Access Compliance Report

Public Rights-of-Way

Intersection ID: 27584	Main Street: ELM_LN	Cross Street: WILLIAMS_POND_LN	Location: NE
ADA ID: 3A5EDCF3CECC	Ramp Type: Perp	Initial Pass/Fail: Fail	Overall Compliance: No
Severity Score: 10			
Codes/Mitigation Info/Possible Solution		Field Measurements/Component Compliance

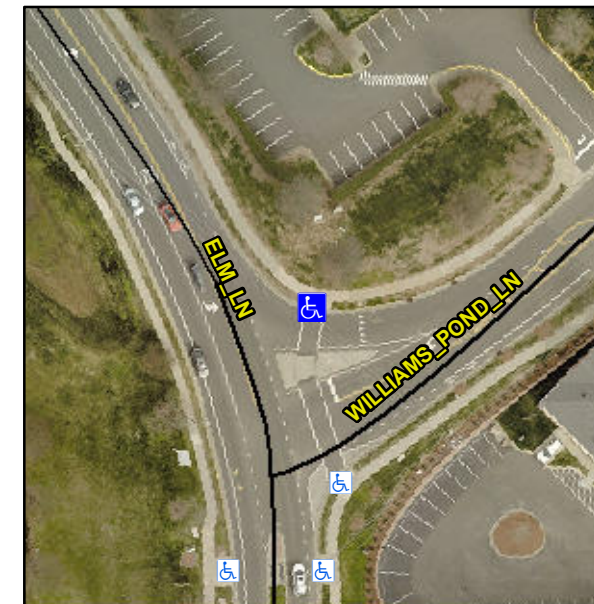
Not Found, R304.5.1, R304.5.3

Compliance	Description	Data	Compliance	Description	Data
N/A	Ramp Length (in)	56.0	Yes	Ramp Slope (%)	7.6
No	Ramp Width (in)	44.0	No	Ramp XSlope (%)	4.4
N/A	Flare Type LT	N/A	N/A	Flare Type RT	N/A
N/A	Flare Slope LT (%)	N/A	N/A	Flare Slope RT (%)	N/A
N/A	Flare Traversable LT?	N/A	N/A	Flare Traversable RT?	N/A
N/A	Landing Length (in)	N/A	N/A	DWS Provided?	N/A
N/A	Landing Width (in)	N/A	N/A	DWS Contrast?	N/A
N/A	Landing Slope (%)	N/A	N/A	DWS Length (in)	N/A
N/A	Landing X Slope (%)	N/A	N/A	DWS Full Width?	N/A
N/A	Landing Curb? (Y/N)	N/A	N/A	DWS Offset (in)	N/A
N/A	Shared Landing?	N/A			
N/A	Gutter Ponding?	N/A	N/A	Gutter Slope (%)	N/A
N/A	Gutter Lip Ht (in)	N/A	N/A	Gutter X Slope (%)	N/A
N/A	Painted X Walk1?	Yes	N/A	Painted X Walk2?	N/A
	X Walk 1 Direction	To SW		X Walk 2 Direction	N/A
N/A	X Walk 1 Width (in)	129.0	N/A	X Walk 2 Width (in)	N/A
	X Walk 1 Slope (%)	0.8		X Walk 2 Slope (%)	N/A
	X Walk 1 X Slope (%)	6.8		X Walk 2 X Slope (%)	N/A

Remove & Replace Entire Ramp.
